ORIGINATION FORM

Proposed Revisions to a Standard Plans Index
(Please provide all information — Incomplete forms will be returned)

Index Number: 700-011
Sheet Number (s): 2 of 2
Index Title: Single Column Cantilever Ground Mounted Sign

BASE AND FOUNDATION DETAIL

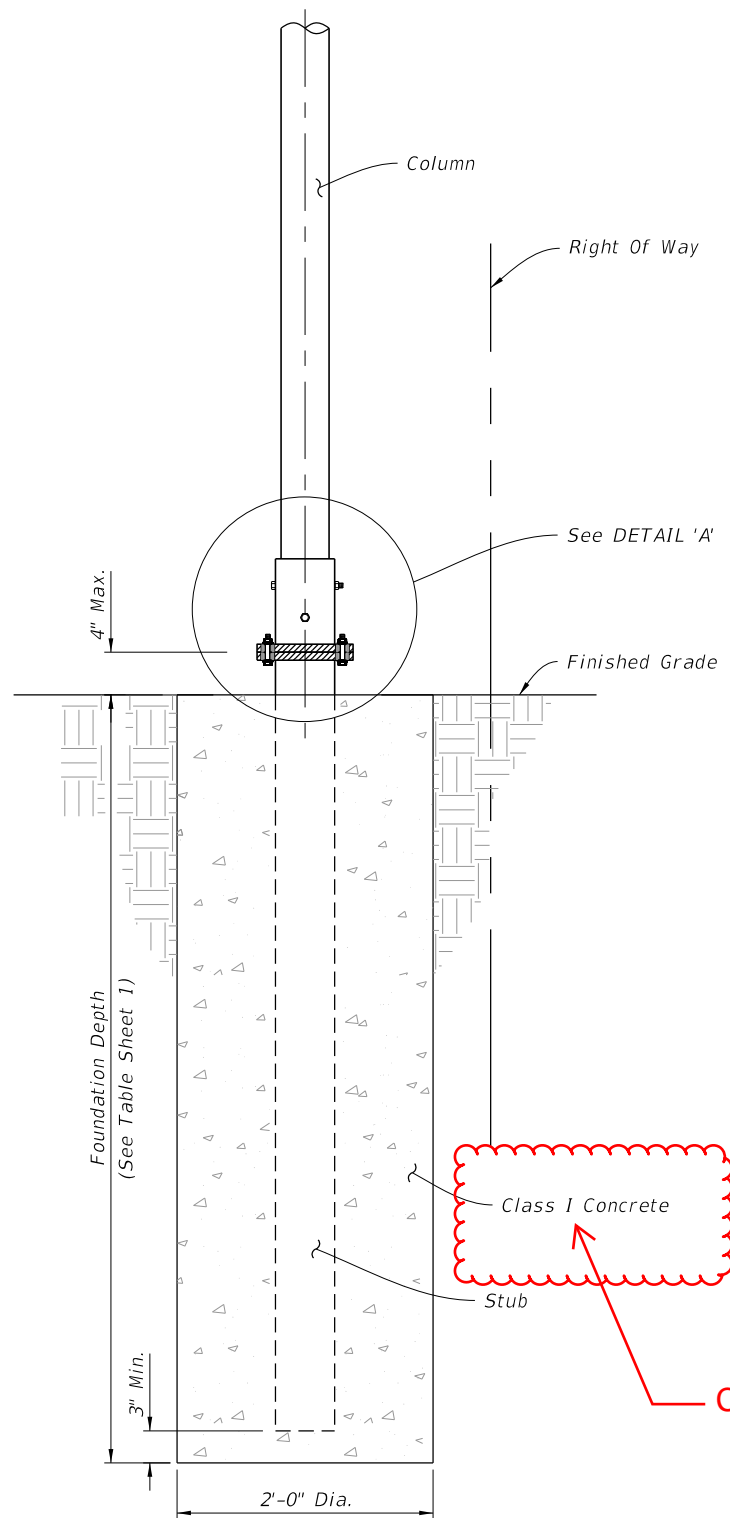
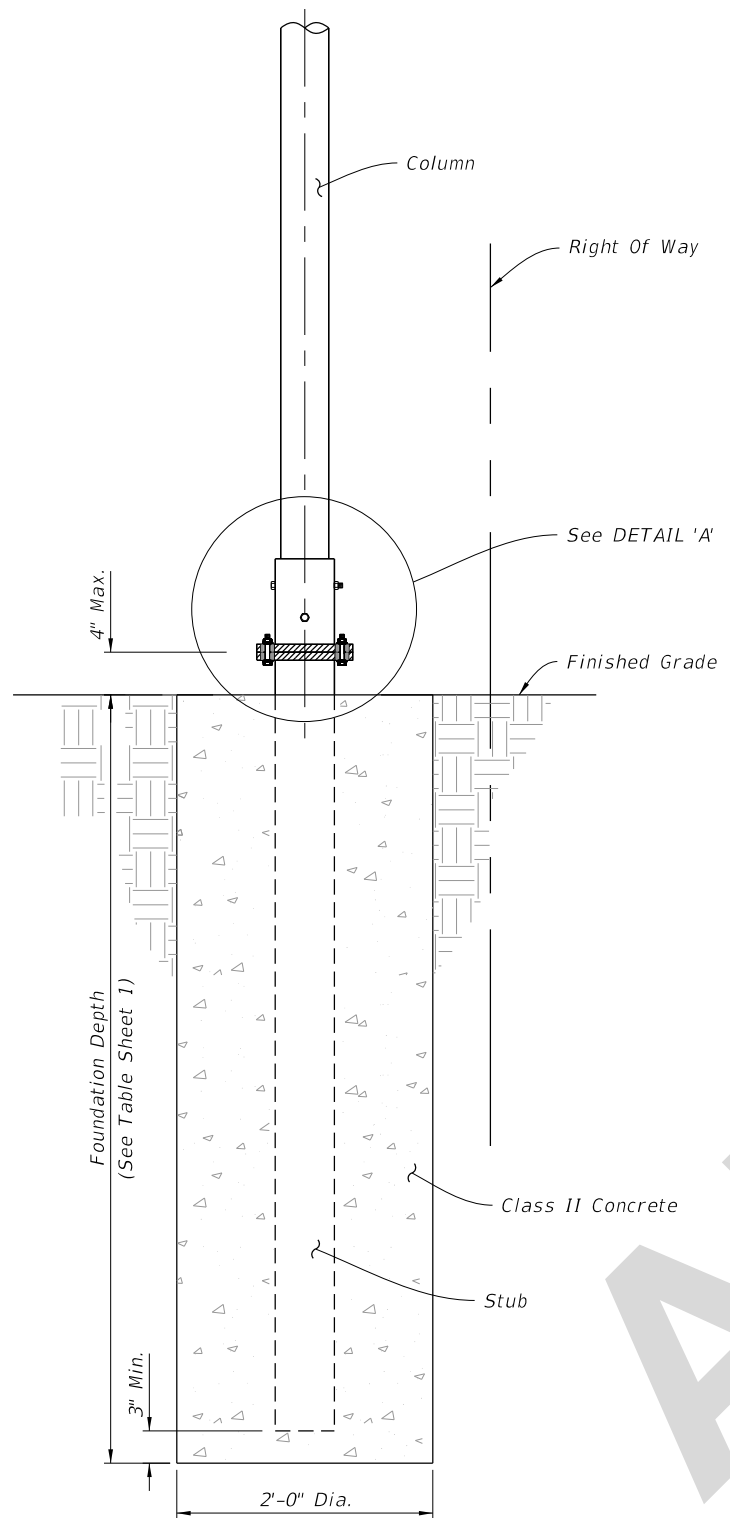
Sheet 2: Changed "Class I" to "Class II" in the BASE AND FOUNDATION DETAIL.

Class I Concrete
Stub
CHANGED TO: Class II

Changed to reflect Materials specification change that removes the designation for Class I Concrete.
Please see the attached Standard Specification Section 346 DRAFT for the Class I revisions proposed by the State Materials Office.
